SHt 2 of 2

SWC 19th & Taraval

PLAN APPROVAL DATE	CONTRACT No.	PROJECT ID	DISTRICT	COUNTY	ROUTE	POST MILES TOTAL PROJECT
	04-0G3501	0400000325	04	SF	1	R0.94/4.05
	SCALE:	19TH AVENUE (STATE ROUTE 1) COMBINED CITY PROJECT				CONTRACT ID. 1000005832
	1" = 5'					DRAWING NO. C-16D
	SHEET OF SHEETS	19TH AVENUE AND TARAVAL STREET CONSTRUCTION DETAILS				FILE NO. 111,351
	54 OF 356					REV. NO

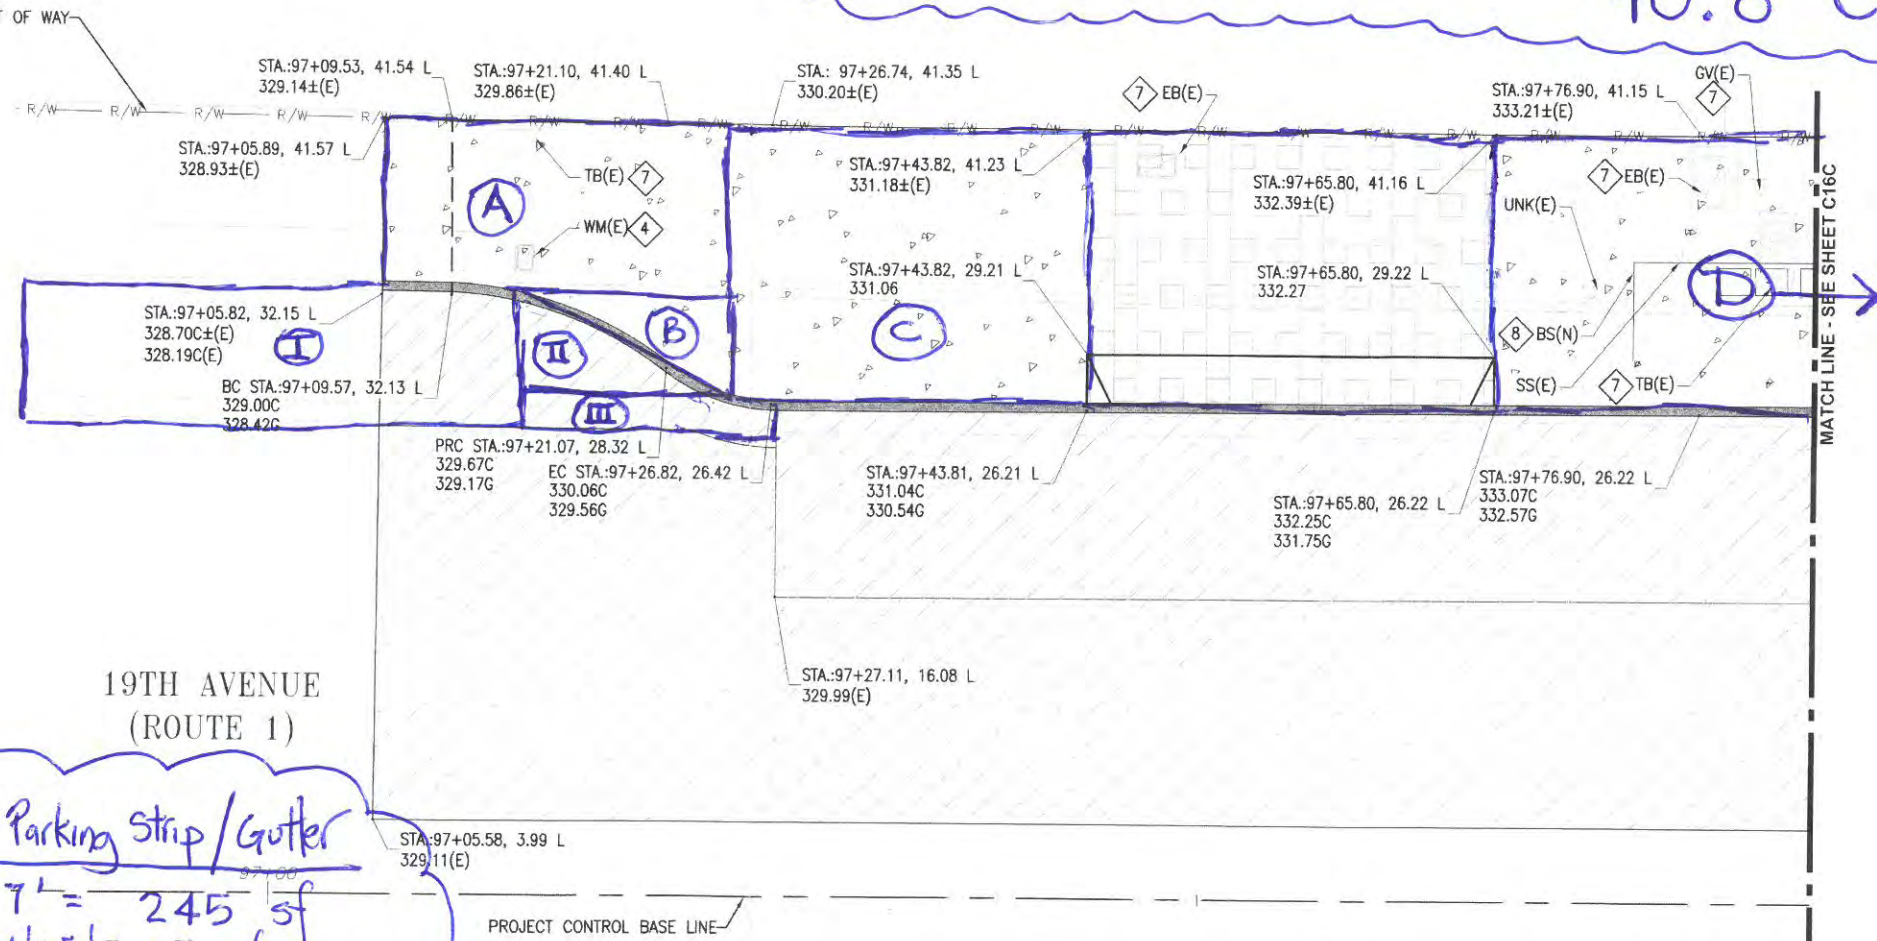
CR-10, 6" Curb
250'

CR-6, 6" Thk, Glass II Aggregate Subbase
CR-5, Bus Pad - $(1,500 \text{ sf} \times 0.5') \div 27 = 27.8 \text{ CY}$
CR-7, 3 1/2" Sidewalk - $(2,556 \text{ sf} \times 0.5') \div 27 = 47.3 \text{ CY}$
CR-9, 6" Sidewalk - $(315 \text{ sf} \times 0.5') \div 27 = 5.8 \text{ CY}$
CR-10, 6" Curb - $(250' \times 0.5' \times 0.5') \div 27 = 2.3 \text{ CY}$
CR-11, Parking strip & gutter - $(412 \text{ sf} \times 0.5') \div 27 = 7.6 \text{ CY}$
Total = 90.8 CY

CR-11, Parking Strip/Gutter
 I 35' x 7' = 245 sf
 II 1/2' x 14' x 5' = 35 sf
 III 2' x 14' = 28 sf
 IV 52' x 2' = 104 sf
 Total = 412 SF
